HIROSE ELECTRIC CO., LTD.
5-23, OSAKI 5-CHOME, SHINAGAWA-KU, TOKYO, JAPAN

Product Change Notification

1	Products affected	①GT25-12DS-HU (CL:775-0037-0-00) ②GT25-12DS-HU/R (CL:775-0062-8-00)									
2	Replacement products	①GT25-12DS-HU(50) (CL:775-0037-0-50) ②GT25-12DS-HU/R(50) (CL:775-0062-8-50)									
3	Classification of change	Material change , Shape change									
4	Description of change	<p>(1)This is to change resin material of housing.</p>

Attachment1 GT25-12DS-HU Comparison of housing shape

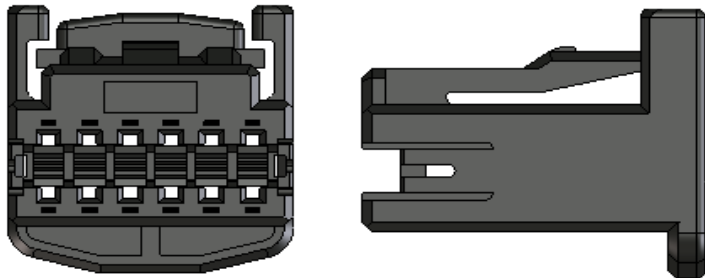
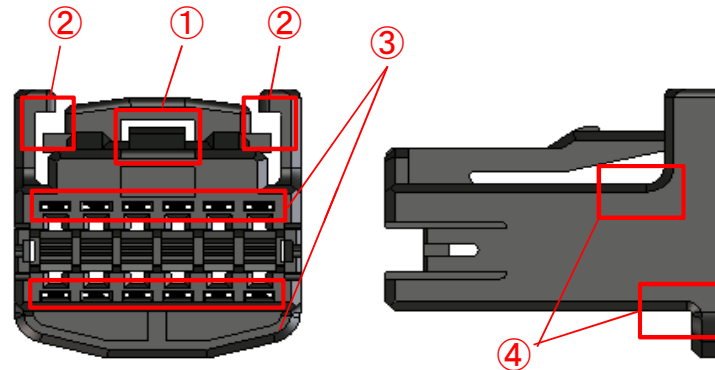
- ①Hole to shape lock-shape . . . Hole dimension expanded
- ②Hole to shape lock guard-shape . . . Hole dimension expanded
- ③Hole to shape lance-shape . . . Hole dimension expanded
- ④Make the corner R-shape

This is to change to the same shape as the other number of positions to improve productivity.
These changes will not affect the performances of the products.
